**APPENDIX H**

**COMMENT LETTERS AND RESPONSES**

Subject: Draft Environmental Impact Statement (EIS) of the Powder River Coal Lease Application and Thundercloud Coal Lease Application

RESPONSES to COMMENT LETTERS RECEIVED ON THE POWDER RIVER AND THUNDERCLOUD DEIS

Proposed Mine Plan With Thundercloud LBA Tract As Applied For Showing Coal Removal By Year.

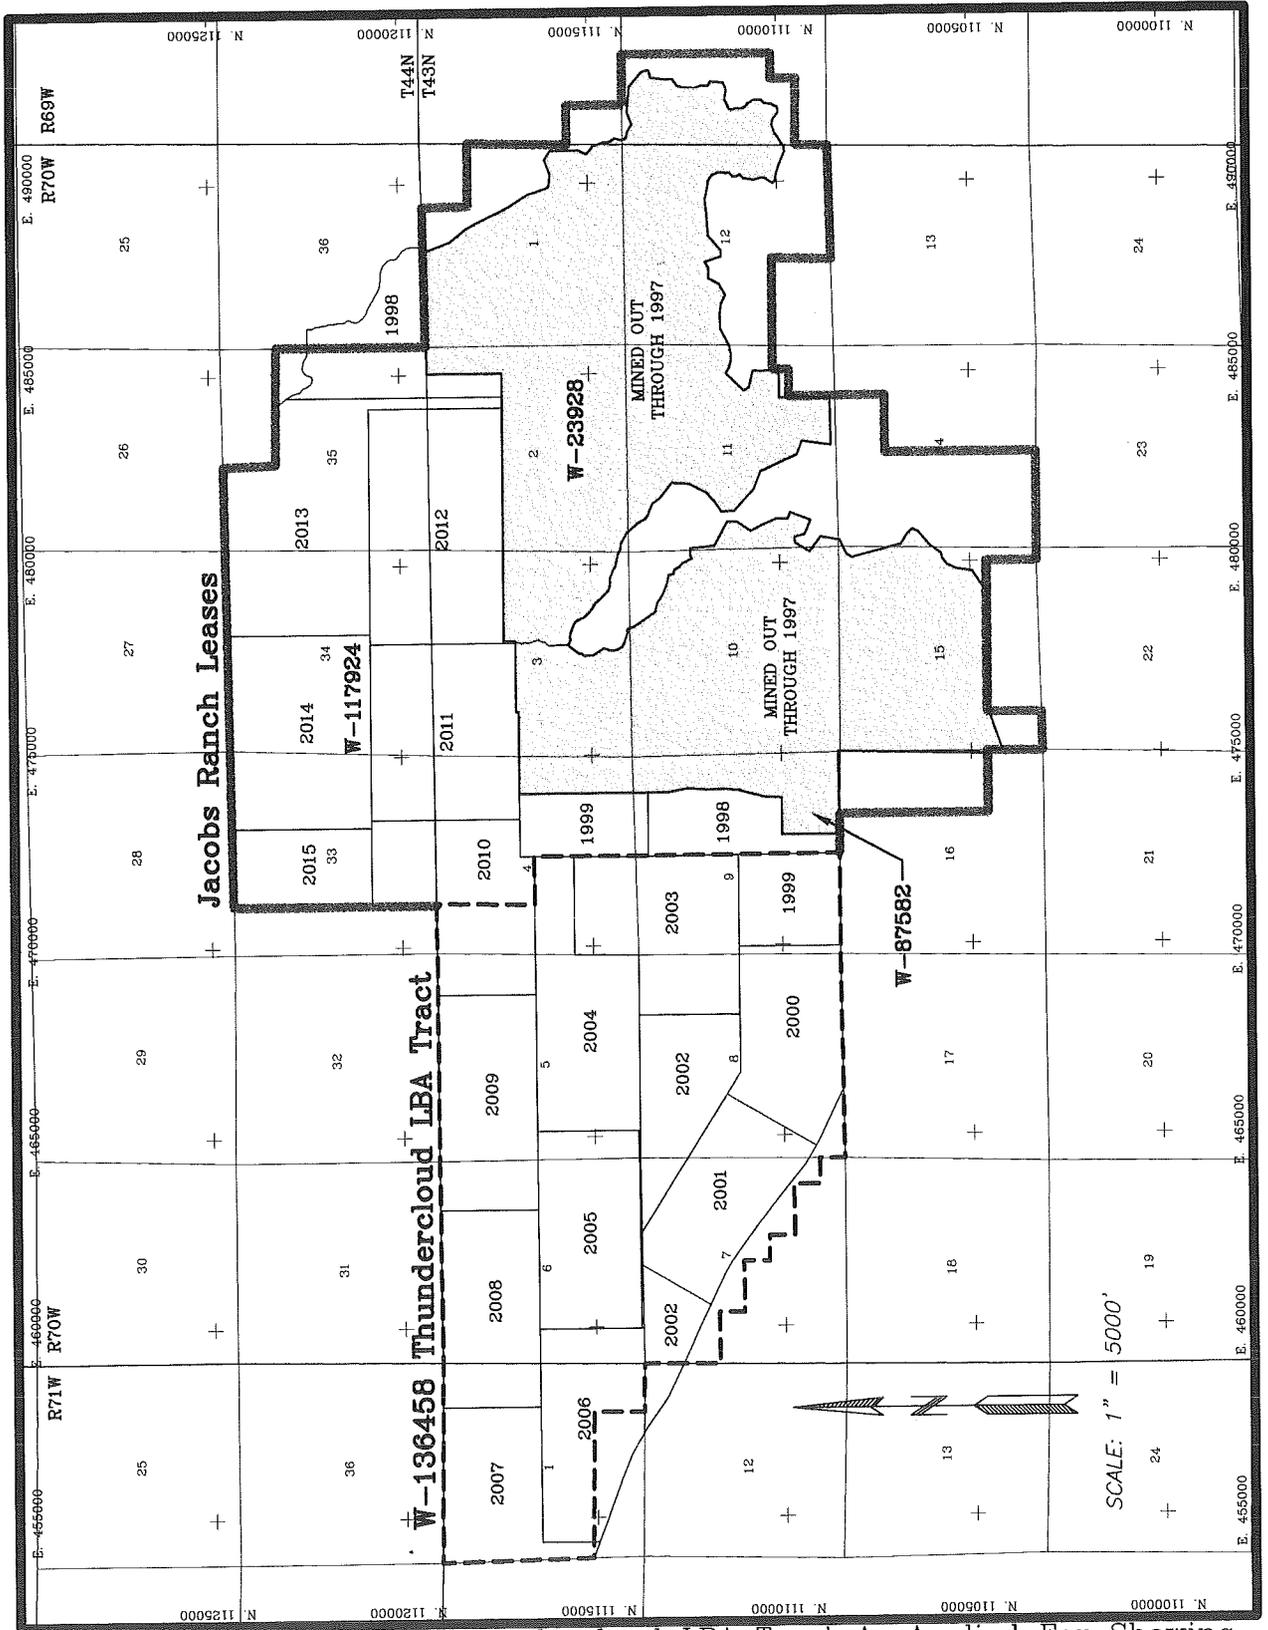
Questions 3 & 4: Please discuss how the BLM values or prices that coal? Is the coal priced on the basis of overburden?

BLM is required to determine the fair market value of federal coal that is being considered for competitive sale. As defined at 43 CFR 3400.0-5(n): "Fair market value means that amount of cash, or on terms reasonably equivalent to cash, for which in all probability the coal deposit would be sold or leased

AIR QUALITY MONITORING SITES

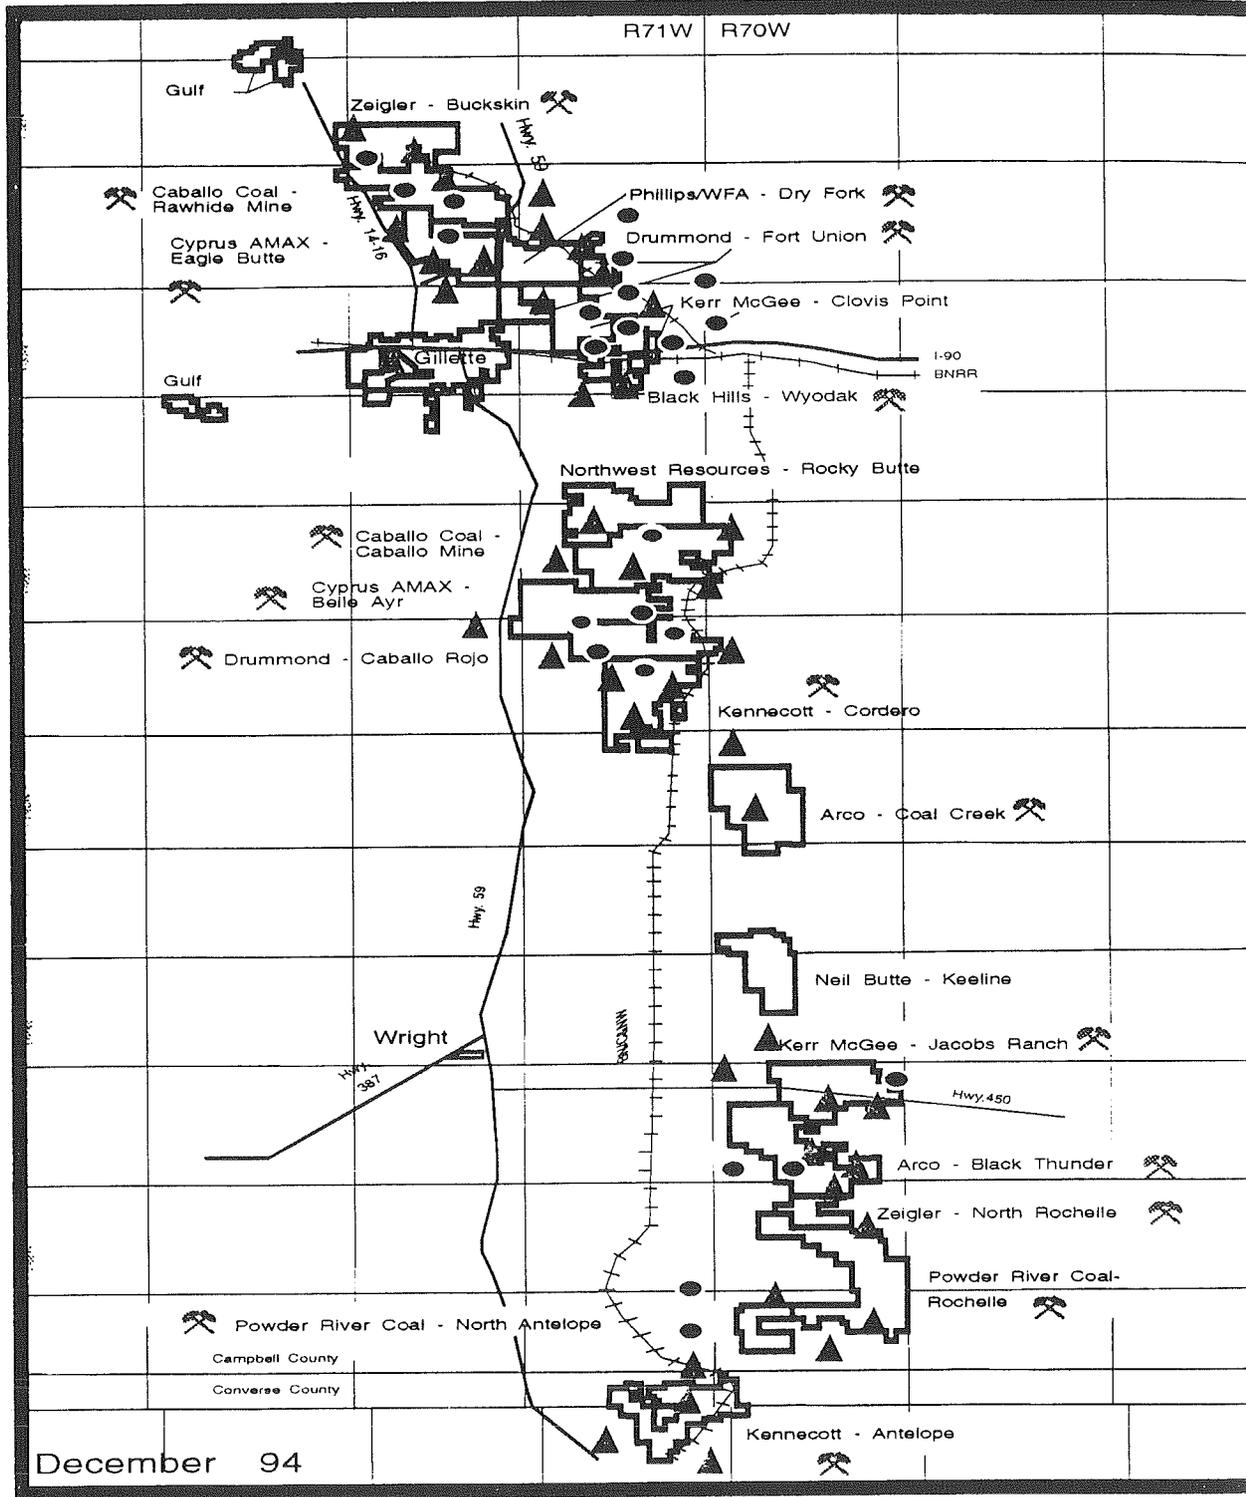
**Letter 10: Environmental Protection Agency, Denver, Colorado**Comment 1:

A wind rose and map showing the air quality sampling locations at the existing adjacent mines is now included for each tract in Chapter 3 of the final EIS document. A map showing air quality monitoring sites for all of the mines in the Wyoming portion of the Powder River Basin is included with this response.
